South Tahoe Public Utility District

# Responsiveness Summary for Item 12 Interim Remedial Action Plan

Feasibility Study of Remedial Alternatives to Mitigate  
Tetrachloroethylene Contamination (Agreement  
D1712508)

**RESPONSIVENESS SUMMARY FOR  
ITEM 12 INTERIM REMEDIAL ACTION PLAN  
FEASIBILITY STUDY OF REMEDIAL ALTERNATIVES TO MITIGATE TETRACHLOROETHYLENE  
CONTAMINATION  
CALSTARS AGREEMENT NO. D1712508  
June 12, 2020**

**Figure 1.** 20-year reverse particle tracking results at the R1 site for Alternative 2, option 2, indicating the 20-year capture zone for this hypothetical well, overlain on PCE contours generated from recent sampling efforts.

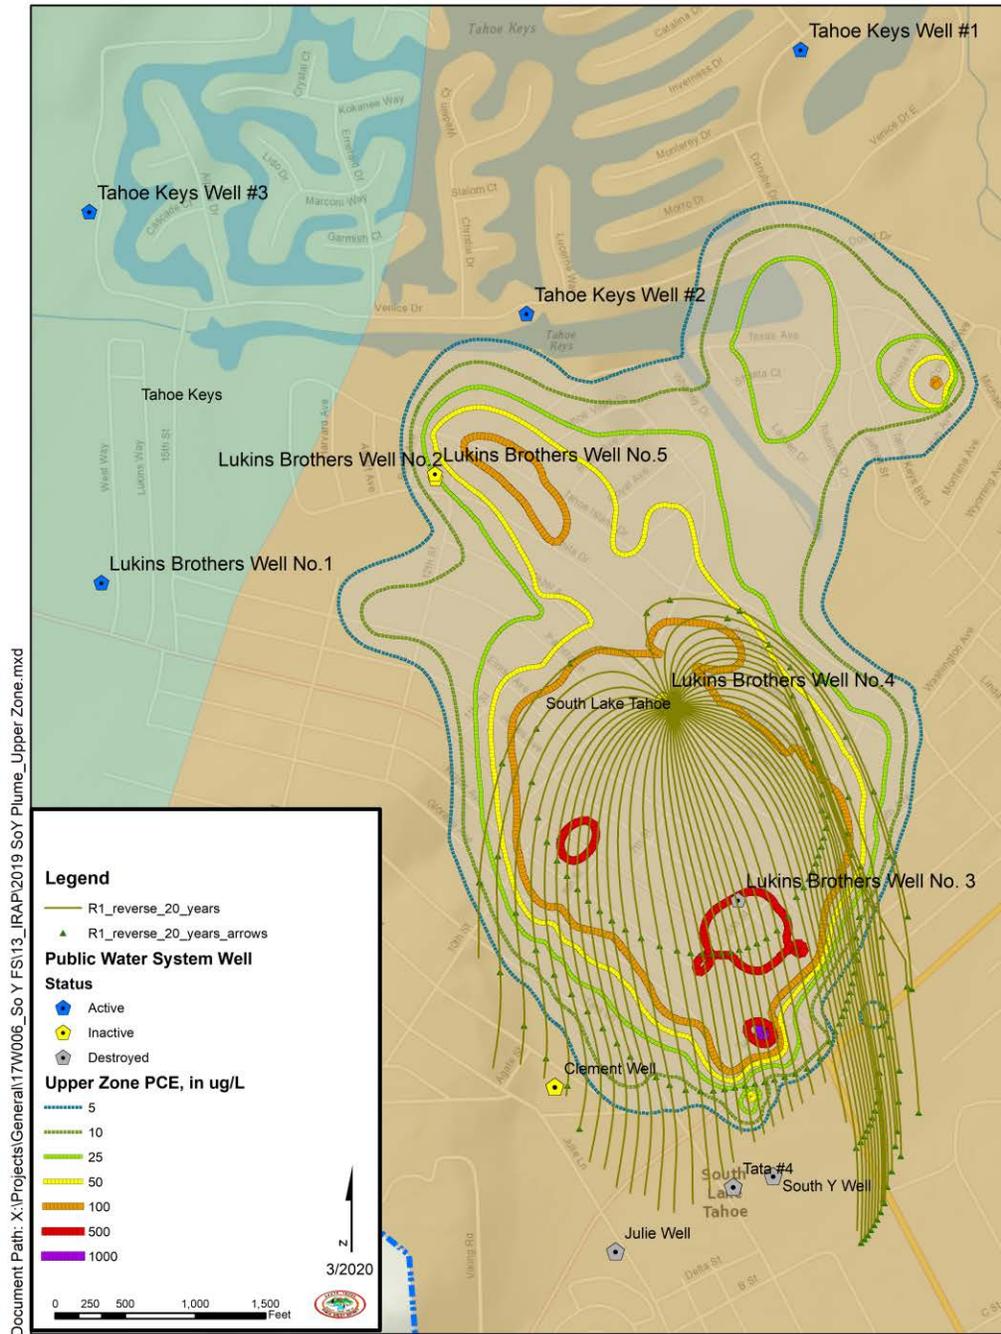
**Comment 6.** Neither the FS nor DRI's modeling report describe the capture zone of the proposed replacement well at LBWC#4 so the effect of operating the replacement well on other parts of the plume cannot be assessed by PES.

**Response.** A 20-year capture zone analysis was completed for Alternative 2, option 2 using reverse particle tracking. The results are shown in Figure 1, overlaid on PCE contours generated from recent sampling.

**Figure 2.** Simulated concentrations at the R1 site for the base (no-action) scenario (Alternative 1A), and Alternative 2A, option 2.

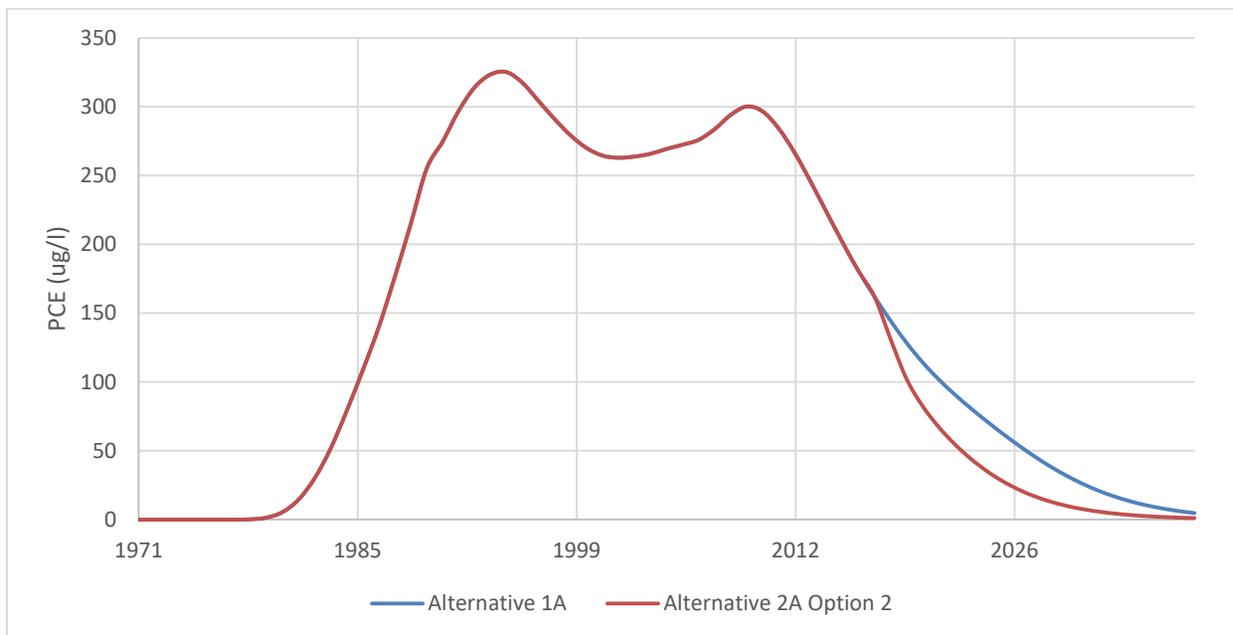
**Comment 7.** In Table 2-2, the PCE mass removed is noted as 800 to 5,000 pounds for preferred remedial alternative, which differs from the range of 700 to 3,500 pounds referenced in the Executive Summary (ES-IV) and Section 6.2.1.1. Which range is incorrect? Are the simulated concentrations from R1 available? Preliminary calculations indicate that the total mass of PCE dissolved in the entire plume is on the order of 1,000 pounds. Based on this analysis and the fact that the preferred remedial alternative is not designed to remove the entire PCE mass comprising the plume. Estimates of GAC use and O&M Costs associated with GAC management should be revised.

**Comment 8.** The assumed/simulated concentration of 325 µg/L (Table 6-3) from well R1 is inconsistent with groundwater analytical data for this area (e.g., 42.5 µg/L at LBWC#4; 71 µg/L at Sonic-3; and 74 µg/L at CPT-E04).

**Response.** Simulated concentrations at the planned location of R1 are presented in Figure 2 for Alternative 1A (Base model) and Alternative 2A, option 2 (Targeted Pumping). The model results for PCE mass removed during 2018-2038 for the Preferred Remedial Alternative is 773 lbs. to 3,293 lbs., which was been rounded to 2 significant figures, 770 lbs. to 3,300 lbs. The correct values have been rounded to 2 significant figures and updated throughout the Feasibility Study and Interim Remedial Action Plan.

**Response.** The concentration reported for R1 in Table 6-3 is the maximum simulated concentration, which occurred in 1994. The simulated concentration at R1 for the base model (Alternative 1A) was 128.4 ug/l for the 2020 WY (Figure 2).
